Washington Public Power Supply System

Docket No. 50-508

Subject: NUCLEAR PROJECT 3
RESPONSES TO NRC ACCEPTANCE
REVIEW QUESTIONS (February 1983)

RESPONSES TO NRC ACCEPTANCE REVIEW QUESTIONS

FIGURE
9.2.5-2a

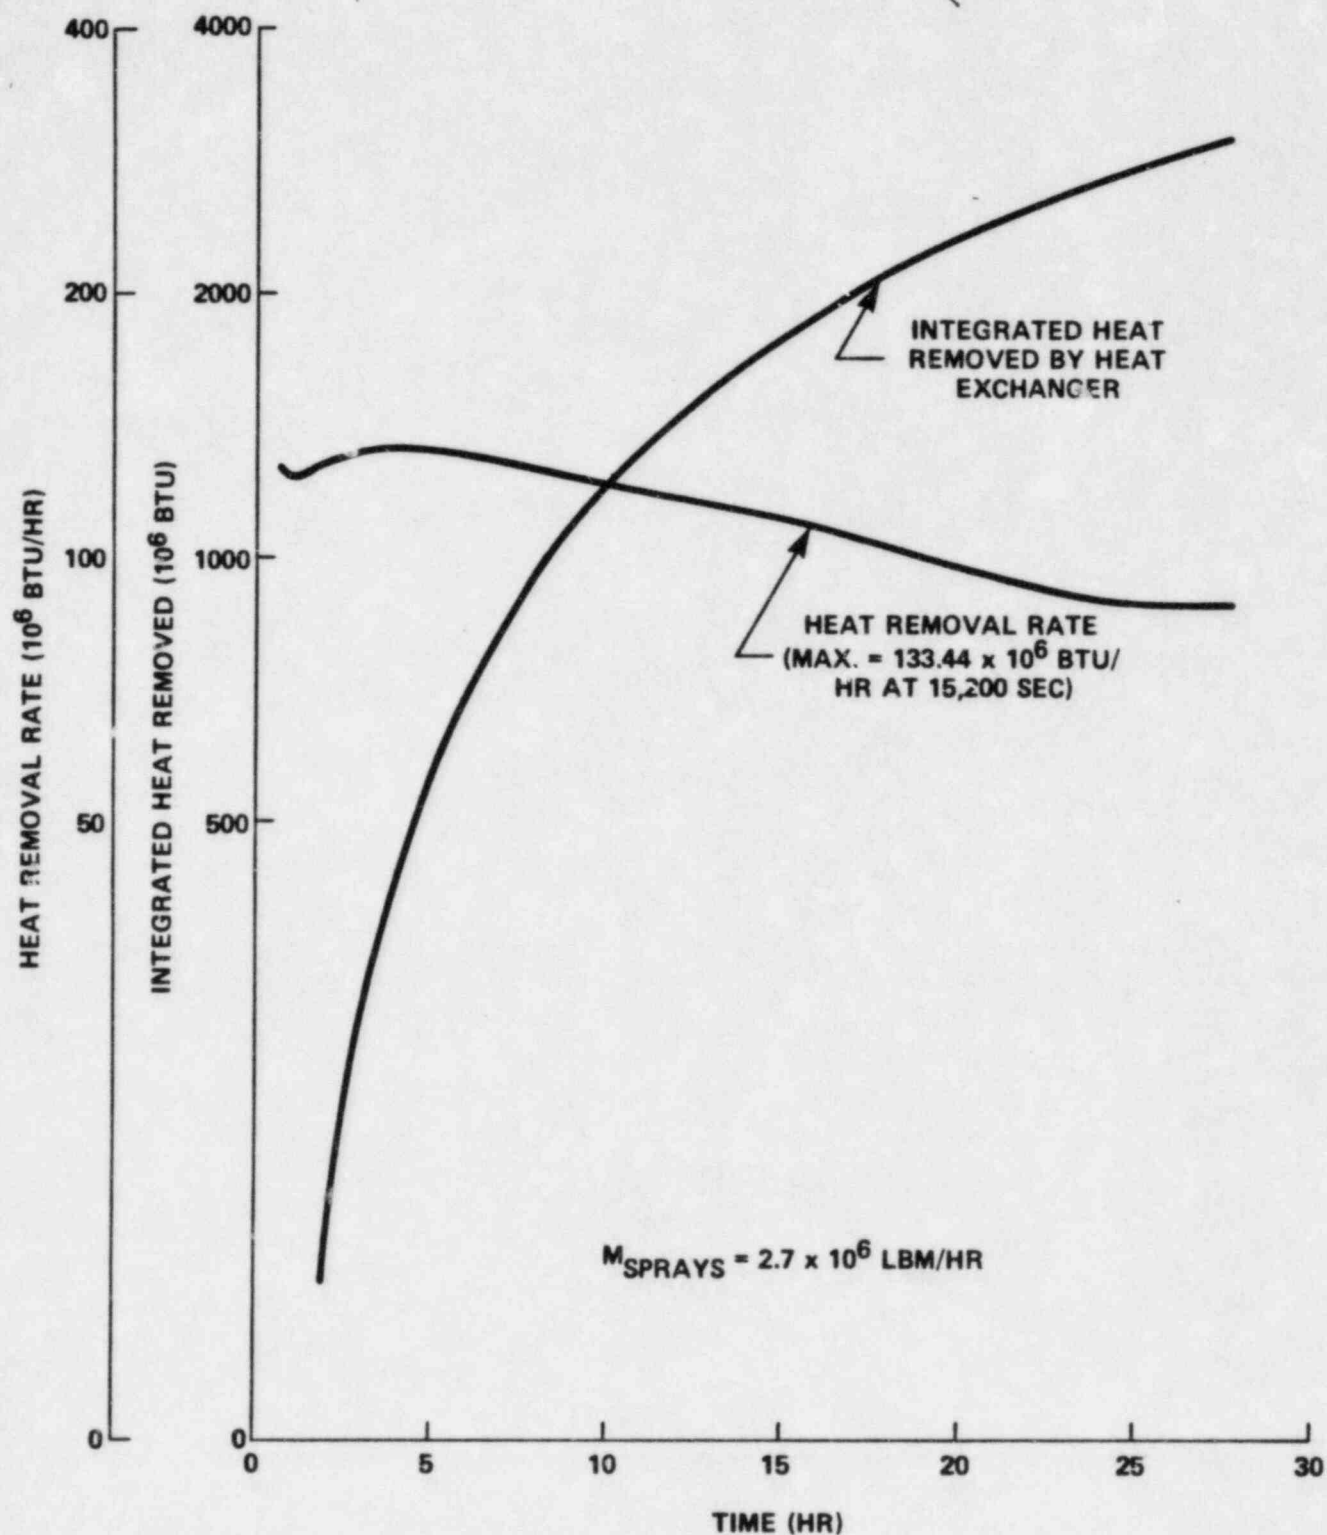
Section 9.2.5 does not define the number of cells per cooling tower train, nor does it contain figures 9.2.5-2a through 9.2.5-2d. Confirm the date by which you intend to supply this information.

As committed to in Letter G03-82-1085 dated October 2, 1982, the attached Figures 9.2.5-2a through 9.2.5-2c are provided for the heat release curve and sensible heat removal curve. This section (replaced by Shutdown Heat Exchanger) this data is covered in Subsection 6.2.1 and 5.4.

The results of an analysis of the 30-day period following a design basis accident are found in Tables 9.2.5-4 and 9.2.5-5 and Figures 9.2.5-2a through 9.2.5-2c. This analysis has determined the total heat rejected, the sensible heat rejected, the station auxiliary system heat rejected, and the decay heat release from the reactor. Details of this analysis are provided in sections 6.2.1 & 5.4.7. | 2
